# Sumter City-County Planning Commission

## MSP-13-50/HCPD-13-26/ CU-13-36, S. Pike West – Wall Street Green Phase 2 (City)

### I. THE REQUEST

1 FRONT ELEVATION - BUILDING TYPE "A"  
1/8" = 1'

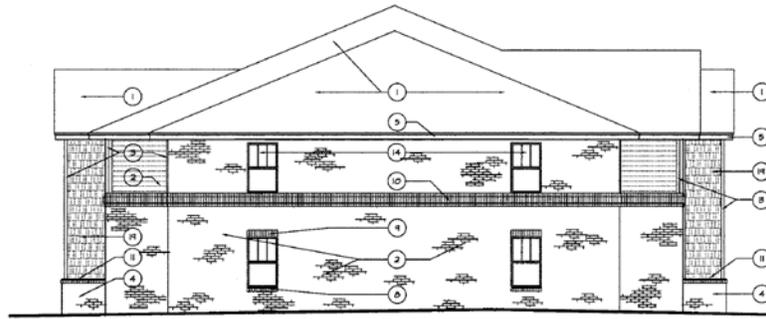
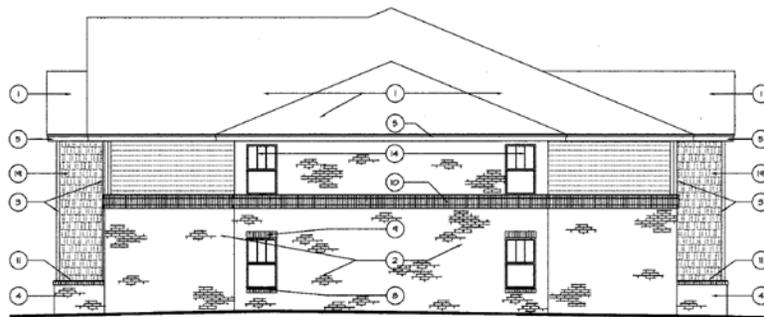
- c. A minimum of eighty percent (80%) of the surface materials, excluding doors and windows, shall be brick, stucco, or stone masonry or materials approved by the Sumter City-County Planning Commission. Building sides clearly visible from street or public view shall be constructed of above mentioned materials or heavily mitigated with landscaping and shown on the required landscaping plan as part of their application. Roof pitch should be compatible with the building structures in the surrounding neighborhood.

The structures will be constructed with a blending of brick, fiber cement board, clapboard siding and fiber cement board shingle siding with asphalt shingle roofs. The proposed structures are compatible with the buildings constructed in Phase 1 of the Wall Street Green Development. The following elevations show the proposed structure.
